Clinton Power Station

Clinton Power Station, Unit 1
Facility Operating License No. NPF-62
NRC Docket No. 50-461

Subject: Additional Information Supporting the License Amendment Request to Permit
Up-rated Power Operation at Clinton Power Station

Additional Information Supporting the License Amendment Request to Permit Upgraded Power Operation at Clinton Power Station (Non-Proprietary)

**Figure 5.1a-1
Batch Offload SFP Decay Heat Load**

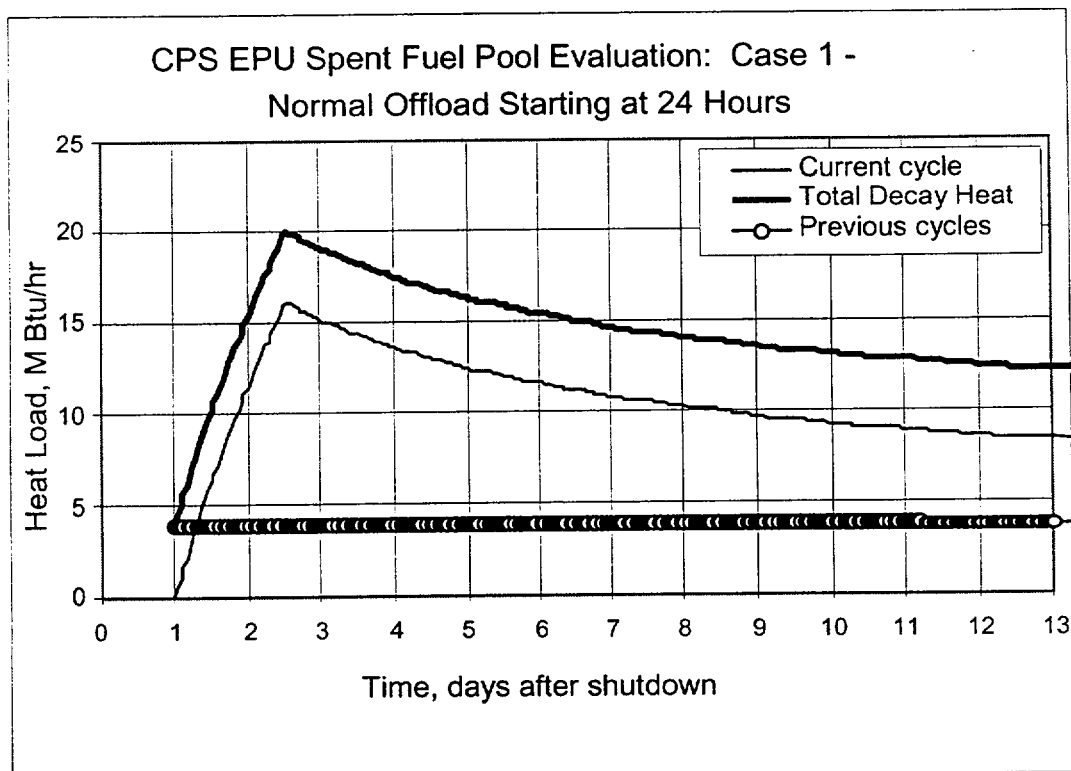
5.1 As a result of plant operations at the proposed extended power uprate (EPU) level, the decay heat load for any specific fuel discharge scenario will increase. In Section 6.3.1 of the Safety Analysis Report (SAR) for Clinton Power Station (CPS) EPU, AmerGen (licensee) stated that EPU does not adversely affect the capability of the fuel pool cooling and cleanup system (FPCCS) to keep the spent fuel pool (SFP) temperature at or below the design temperature and maintain adequate SFP cooling during normal refueling and under full-core offload conditions. However, AmerGen did not provide the detailed discussion of its SFP cooling evaluations in the SAR, please provide the following information for both pre-EPU and EPU conditions.

5.1a SFP heat loads and the corresponding peak calculated temperatures during planned (normal) partial and/or full-core offload outages and unplanned (abnormal) full-core offload outages for pre-EPU and EPU conditions. A planned offload is the offload of fuel assemblies to the SFP for any expected (or planned) reason (e.g., refueling outage). An unplanned offload is the offload of fuel assemblies to the SFP due to an unforeseen condition (e.g., unexpected shutdown that includes an offload).

5.1a The following Figures 5.1a-1 through 5.1a-4 show the calculated response of the SFP for partial and full-core offloads for EPU conditions.

**Figure 5.1a-3
Batch Offload SFP Temperature**

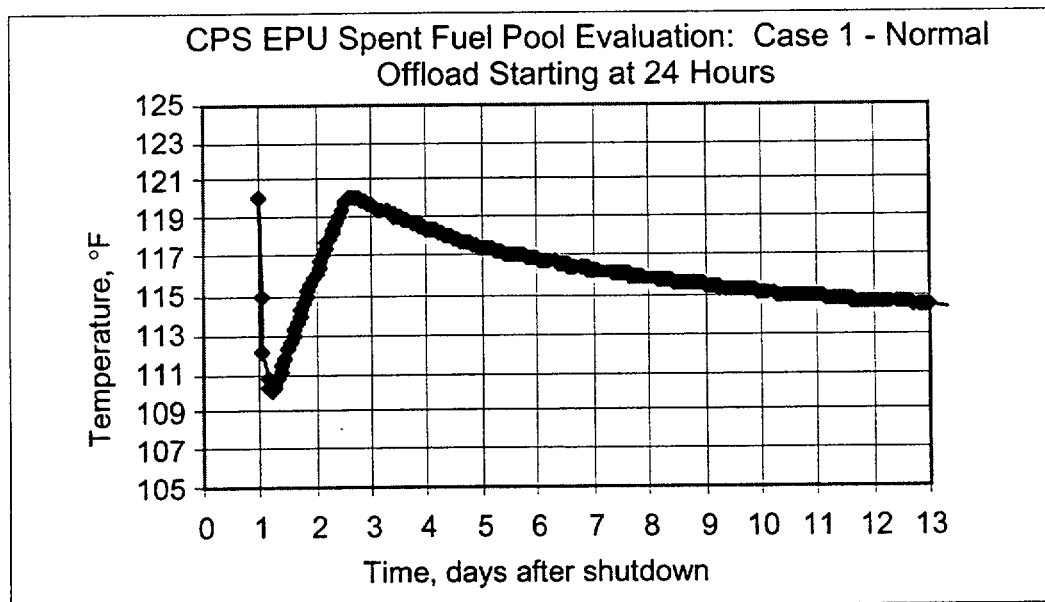
5.1e For the planned refueling outages (with either partial or a full-core offload), if the calculated peak SFP temperature is above 150°F, provide thermal stress analyses to demonstrate that the SFP structure can withstand the new high temperature for the duration of time during which the SFP temperature is above 150°F. Mechanical and Civil Engineering Branch (EMEB) has the primary review responsibility for structural thermal stress analyses.

5.1e As demonstrated in the graphs above (i.e., Figures 5.1a-3 and 5.1a-4), the SFP temperature does not exceed 150°F for the planned refueling outage heat load, for either partial or full-core offload.

**Figure 5.1c-1
Batch Offload SFP Temperature for Accident Condition**

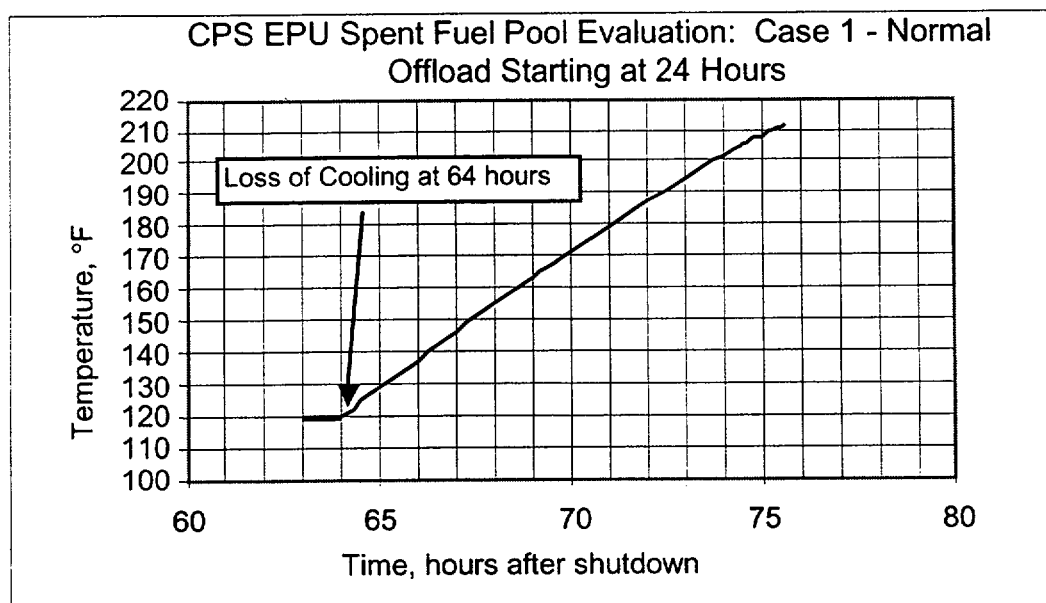
5.1c For the planned refueling outages (with either partial or a full-core offload), discuss how the most severe single failure (e.g., failure of: a FPCC system train, a residual heat removal system train, emergency diesel generator, etc.) has been identified and accounted for in the SFP thermal-hydraulic analyses. (A single failure need not be assumed for the unplanned full-core offload events.)

5.1c The accident conditions are initiated at the peak SFP temperature for partial and full-core offload scenarios, by assuming that the entire FPCCS cooling capacity is lost. The results of the analysis are shown in Figures 5.1c-1 and 5.1c-2.

**Figure 5.1c-2
Full Core Offload SFP Temperature for Accident Condition**

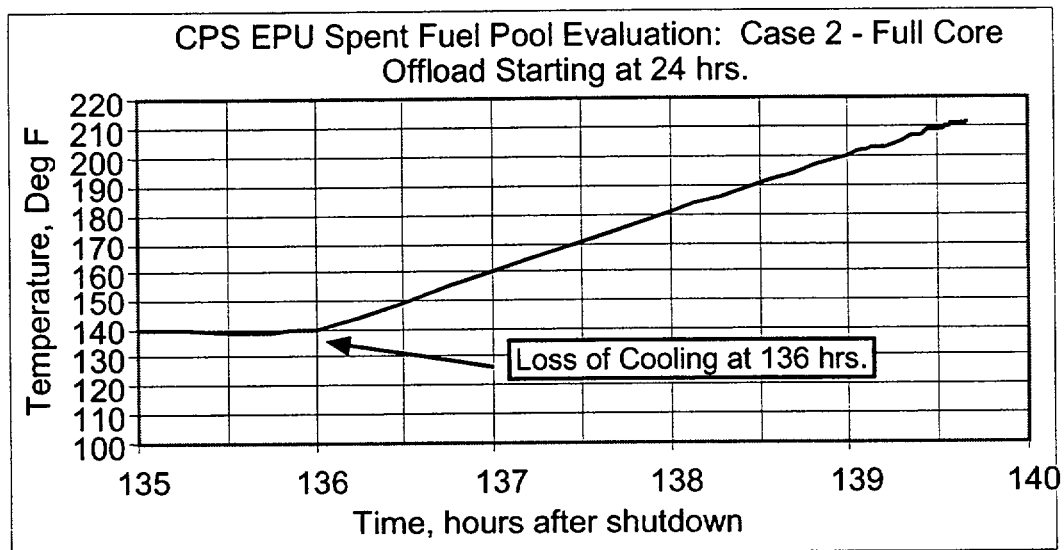
5.4c Information supporting a determination that there is sufficient time for operators to intervene in order to ensure that the temperature limit of 150°F will not be exceeded.

5.4c Based on the graph above for the worst case scenario, (i.e., a full-core offload with a complete loss of SFP cooling starting at the peak SFP temperature of 140°F as described in Figure 5.1c-2), the amount of time for operator action to prevent exceeding 150°F SFP temperature is greater than 30 minutes. Since a system malfunction that would initiate a loss of cooling is annunciated in the Main Control Room, sufficient response time remains for the operators to take actions to mitigate the temperature rise.
